REDLANDS SUBDIVISION, PHASE 1

APPLICATION NUMBER 4 DATE March 15, 2018

DETAIL SITE PLAN

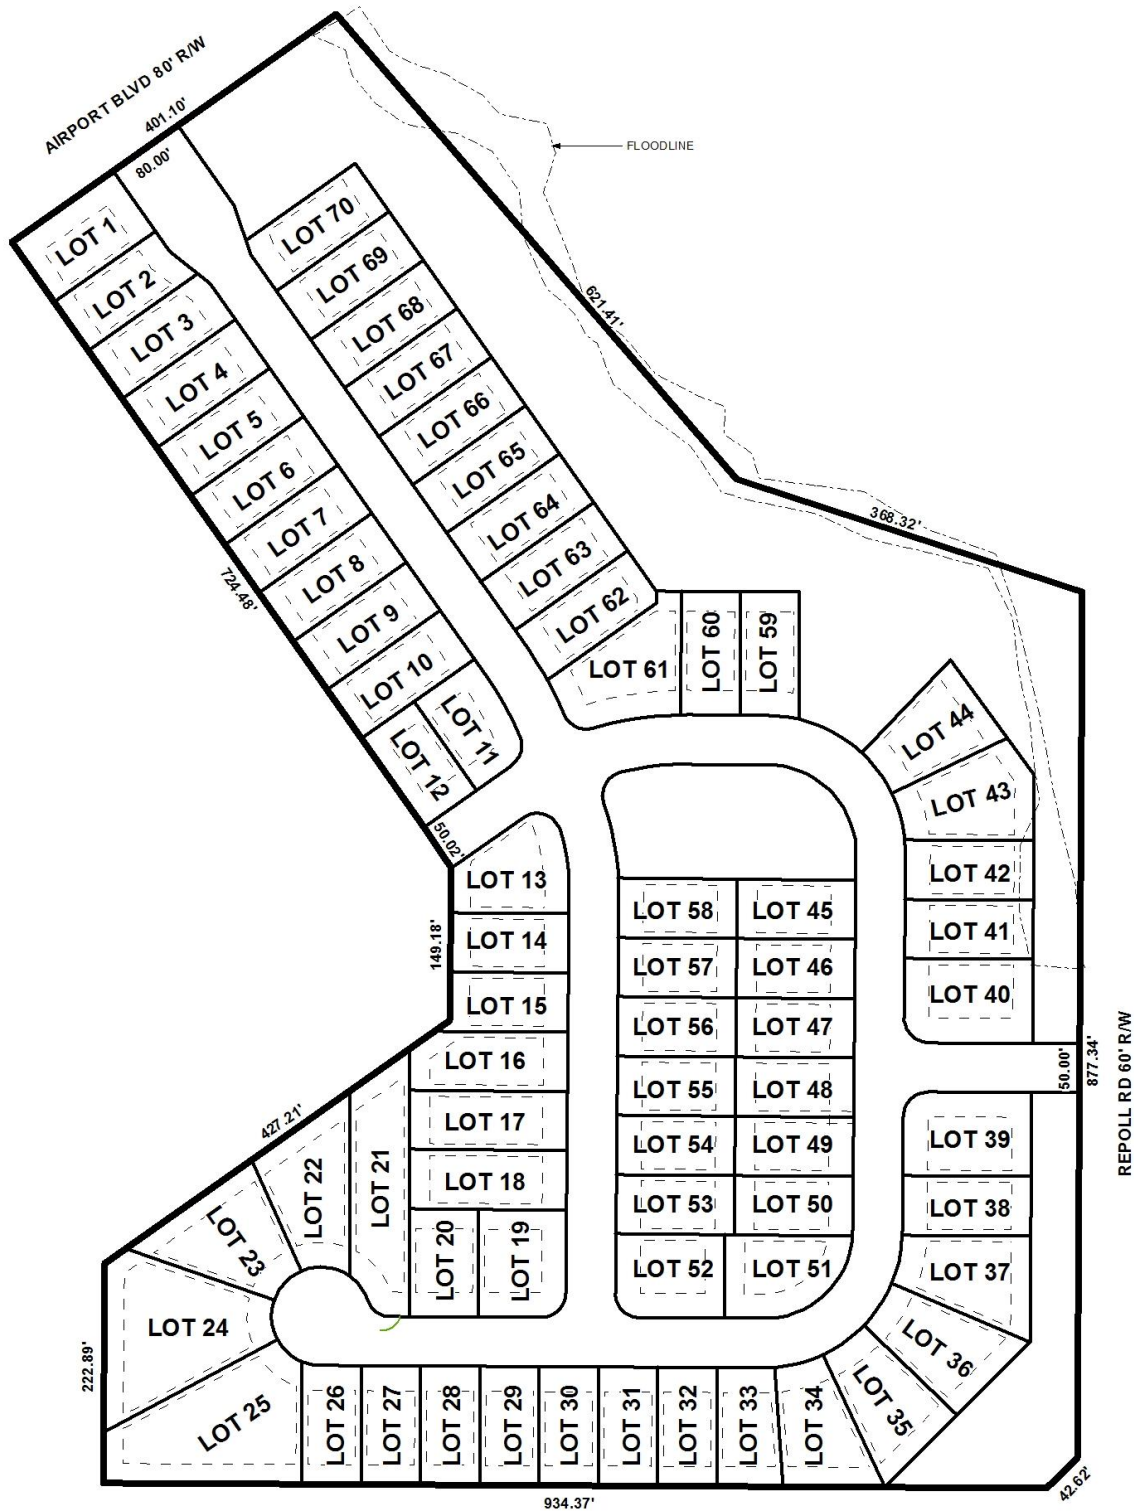
The site fronts Airport Boulevard and Repoll Road. Airport Boulevard is a proposed major street with a planned 100' right-of-way, as illustrated on the Major Street Plan. However, the plat indicates the right-of-way width of Airport Boulevard as 80'. Therefore dedication of any necessary right-of-way to provide 50' from centerline of Airport Boulevard will be required. The plat depicts Repoll Road as having a 60' right-of-way; therefore no dedication will be required. The site is also bounded along the west side by a proposed major street, a new connection linking Eliza Jordan Road to Johnson Road West. The right-of-way is proposed to be 100 feet, thus the plat should be revised to reflect dedication of the right-of-way.

No overall composite plan showing all proposed phases has been provided for the proposed Redlands Subdivision, thus staff has no information regarding the ultimate proposed number of lots, nor the total number of access points for the subdivision.

- 1) an overall plan for the Redlands Subdivision, depicting all proposed phases can be submitted by March 28th;
- 2) revision of the proposed subdivision to accommodate the proposed Eliza Jordan Road major street extension; and
- 3) advise the applicant to Holdover Phase 2, currently set for the April 5th agenda to April 19th to make revision to reflect the major street plan.
